ADDENDUM #01

October 29, 2025

TO CONTRACT DOCUMENTS FOR:Project #CP241934 – Memorial Stadium Facilities –
SEZ Recruiting Room Fitout**ADVERTISEMENT DATE:**

CONSULTANT:Simon Oswald Associates, Inc.
2801 Woodard Drive, Suite 103
Columbia, MO 65202
(573) 443-1407

OVERALL PLAN - RECRUITING - USE OF PREMISES
SCALE: 1/32" = 1'-0"

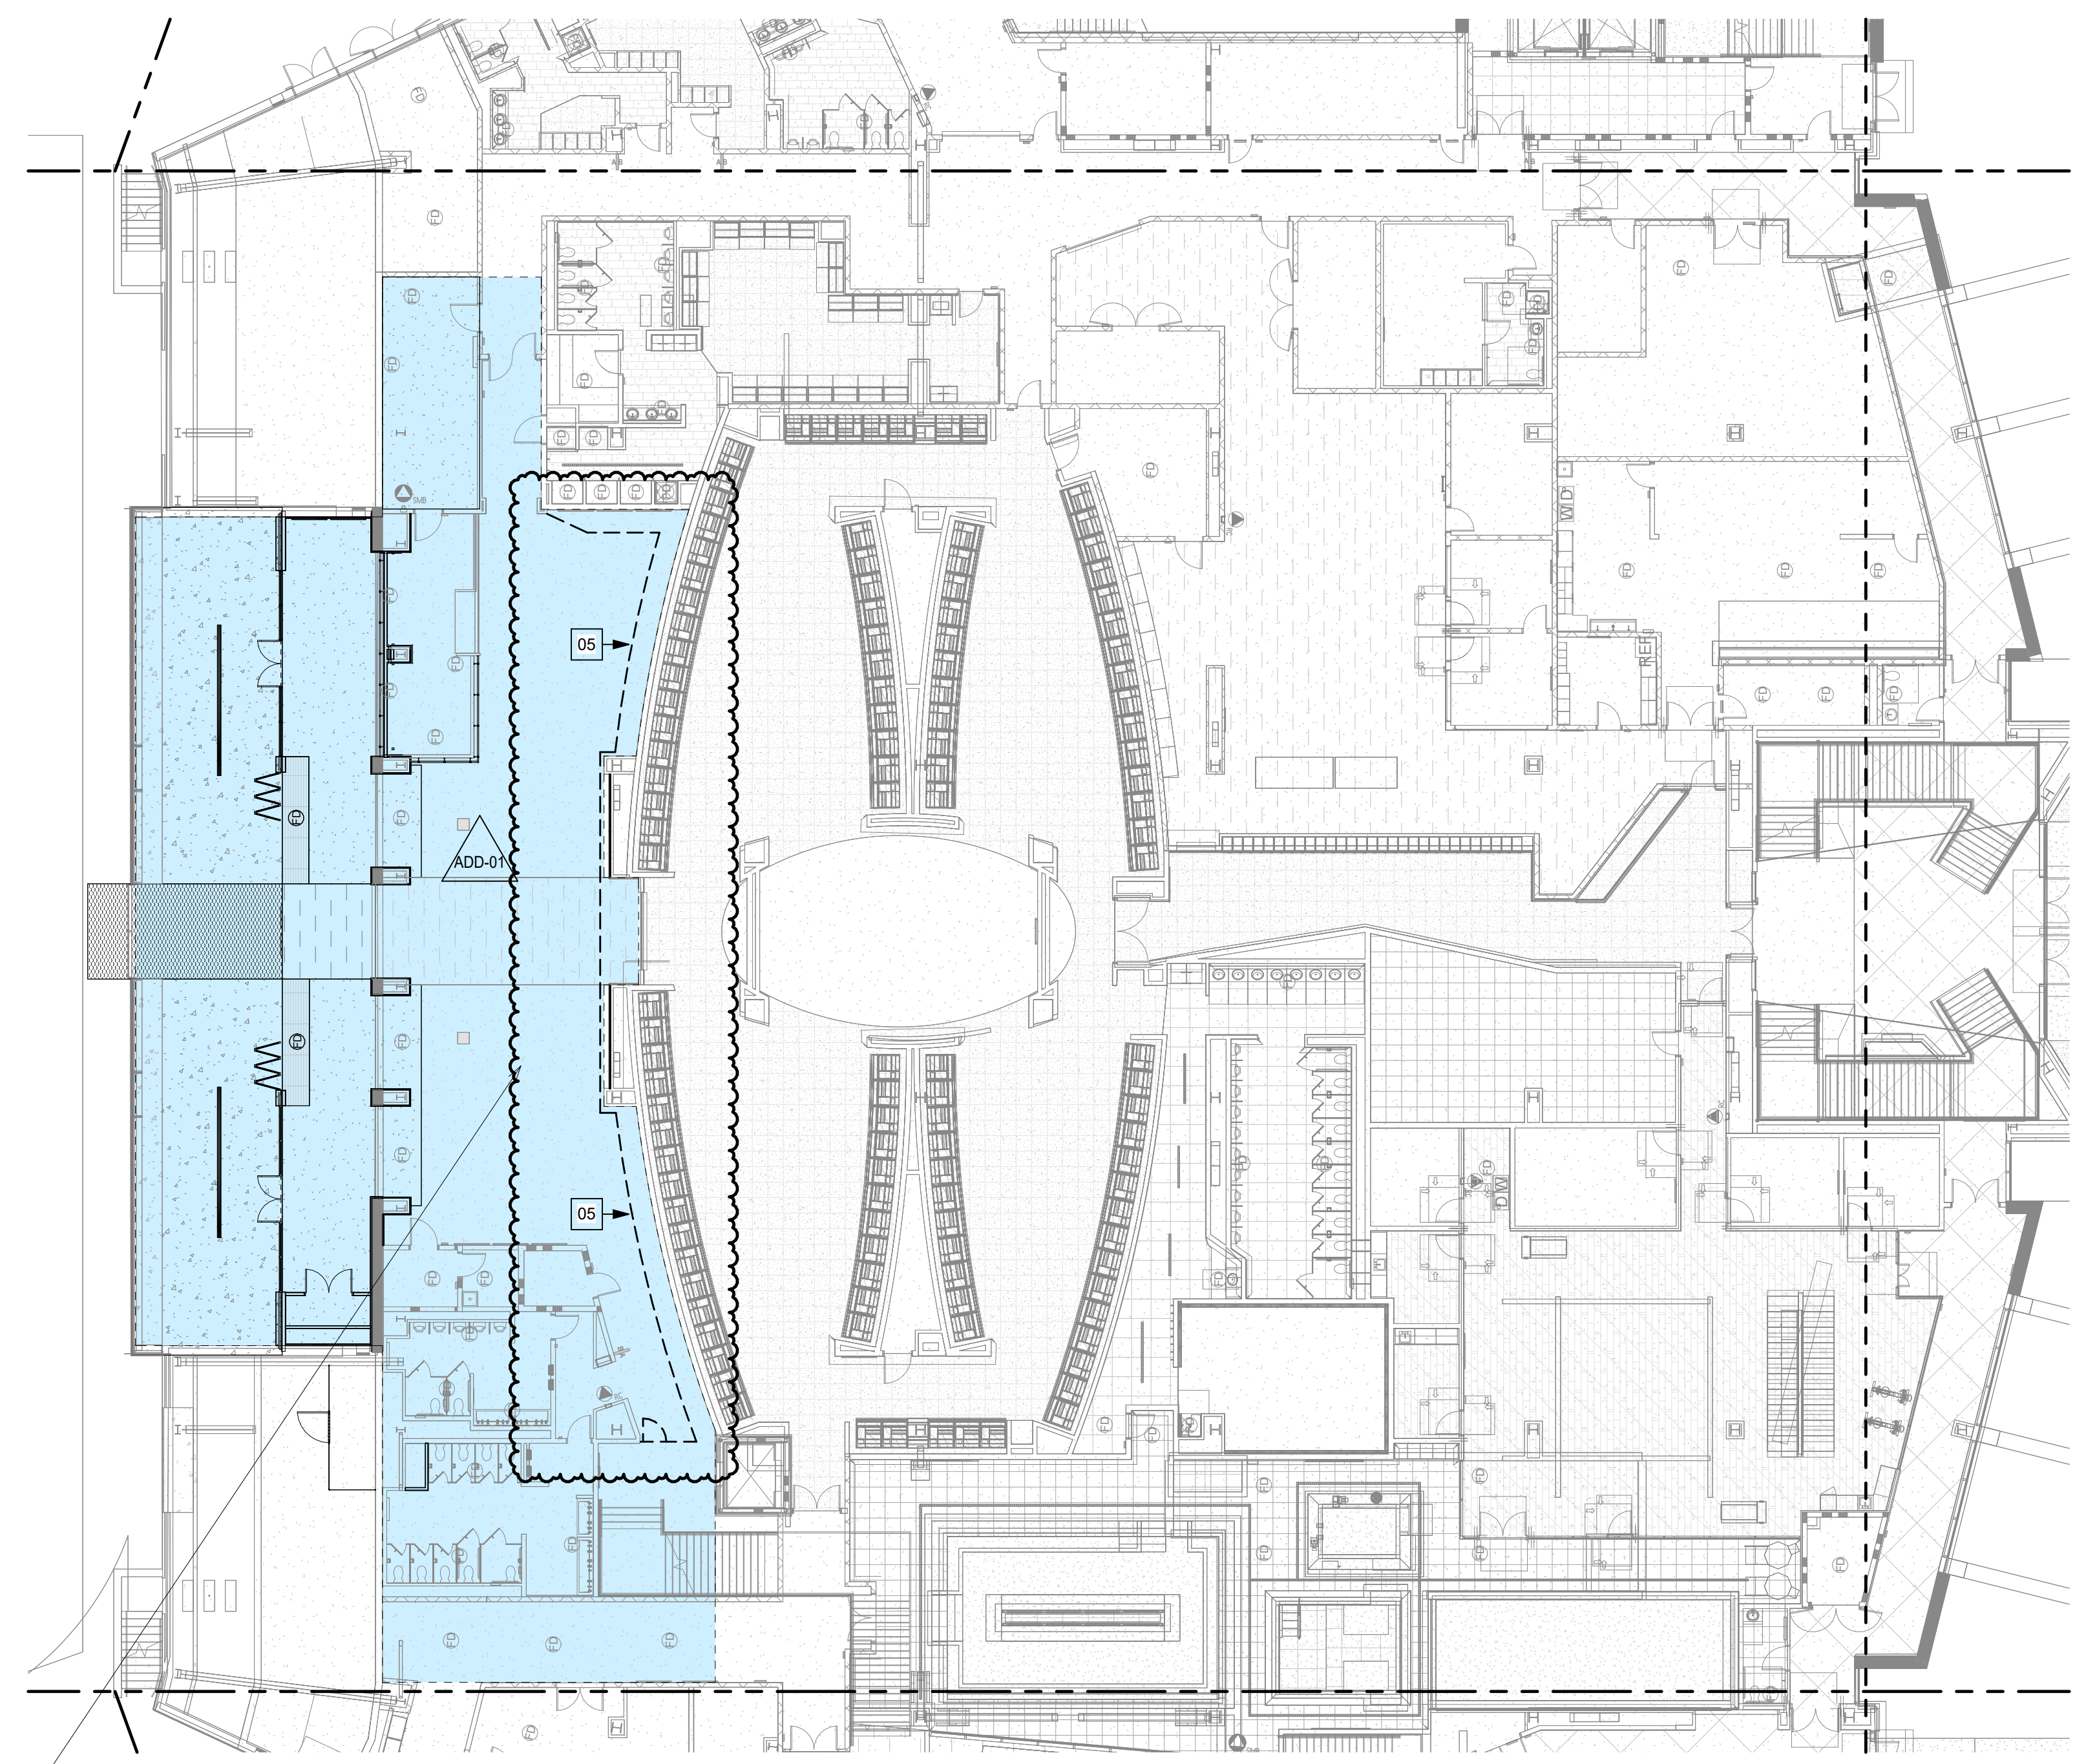
- 1) Drawing sheet G0.2: **REPLACE** sheet G0.2 dated 10/02/2025 in its entirety with revised sheet G0.2 dated 10/29/2025 attached. Revise Use of Premises Keyed Note 04 to clarify the Heavy Duty Protection Mats will be Owner Furnished Owner Installed. Revise Use of Premises Keyed Notes to add note 05 for plastic barrier to protect existing walls not receiving work. Revise Overall Recruiting Room Plan to add keyed note 05 for locations of plastic construction barrier to protect existing walls.

FIELD LEVEL - AREA G - RECRUITING ROOM - DEMO PLAN
SCALE: 1/8" = 1'-0"

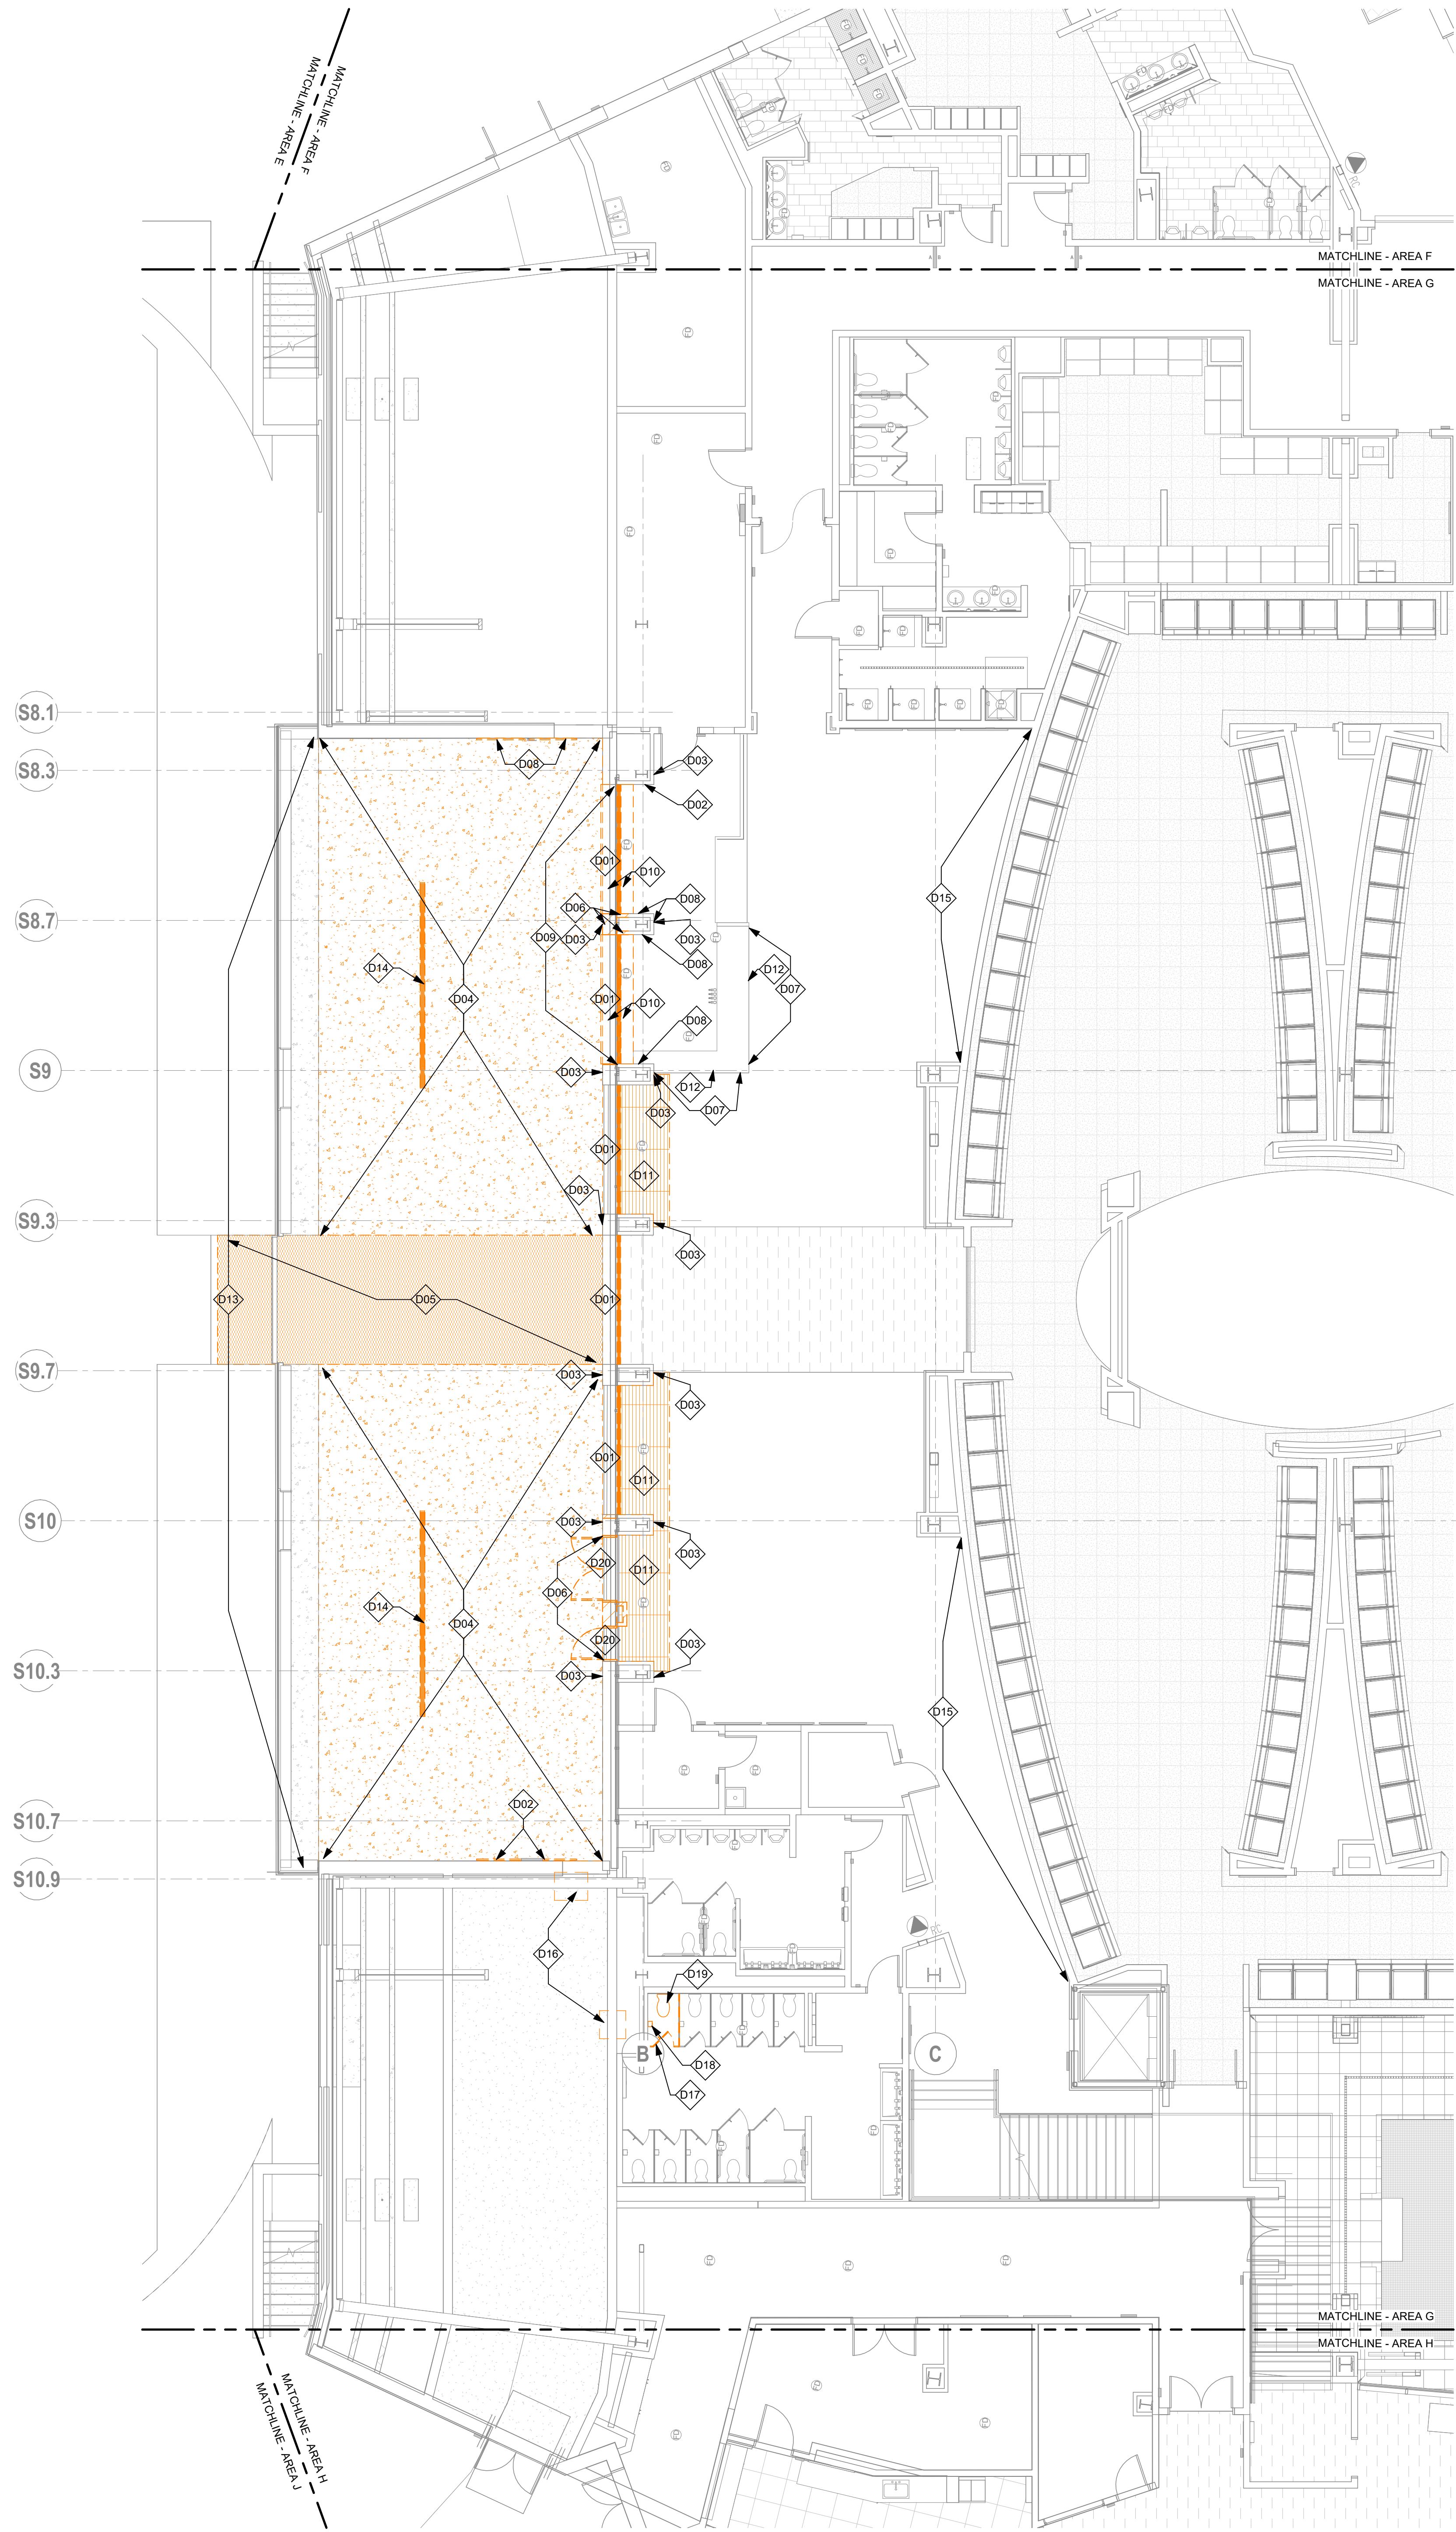
- 5) Drawing sheet A102: **REPLACE** sheet A102 dated 10/02/2025 in its entirety with revised sheet A102 dated 10/29/2025 attached. Revise Keyed Notes D01 and D20 to clarify the overhead doors and doors are to be salvaged and returned to the Owner.

- ADD-01 OVERHEAD DOOR AND ASSOCIATED TRACK ABOVE - REMOVE AND SALVAGE TO OWNER
- D01 OVERHEAD DOOR AND ASSOCIATED TRACK ABOVE - REMOVE AND SALVAGE TO OWNER

04 WALL SECTION
A601 SCALE: 3" = 1'-0"

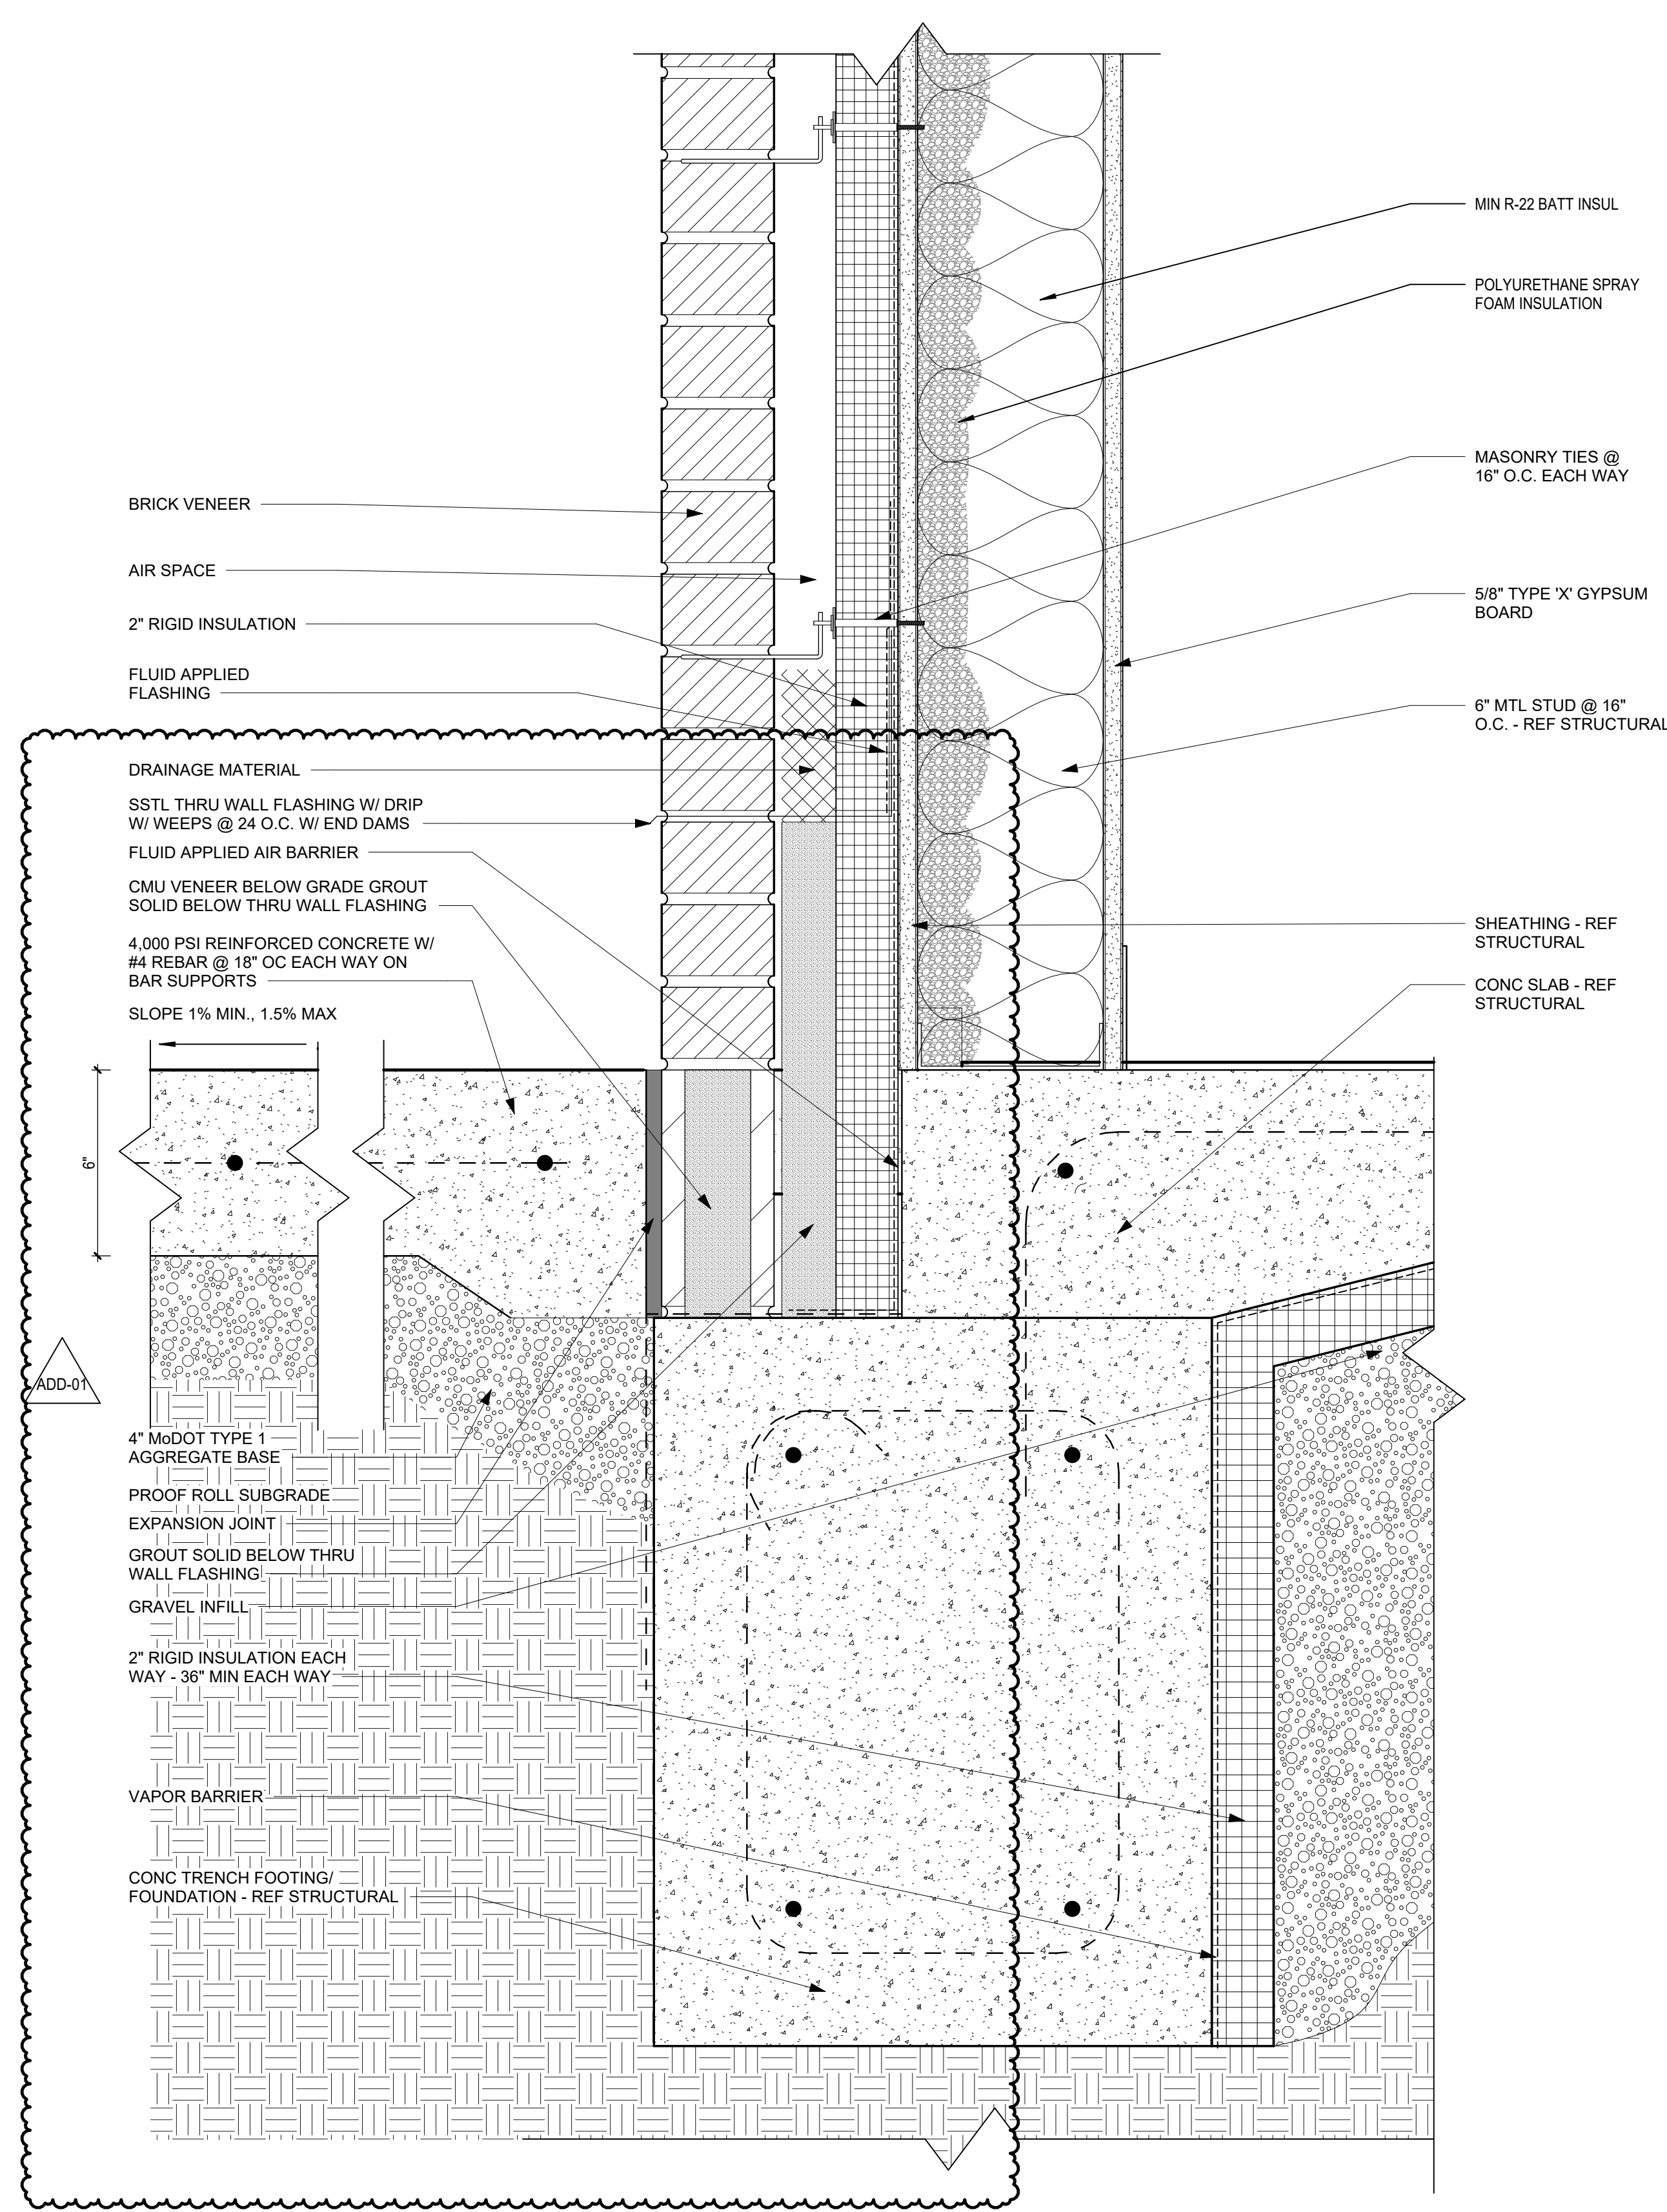
- 6) Drawing sheet A601: **REPLACE** sheet A601 dated 10/02/2025 in its entirety with revised sheet A601 dated 10/29/2025 attached. Revise Wall Section 04 and Head Detail 08 to clarify metal wall panel at top of wall and site concrete at base of wall of Detail 04. Revise Detail 10 to clarify vapor barrier overlap requirements. Revise sheet to eliminate Detail 09 which does not apply.

DETAIL 09/A601 NOT USED
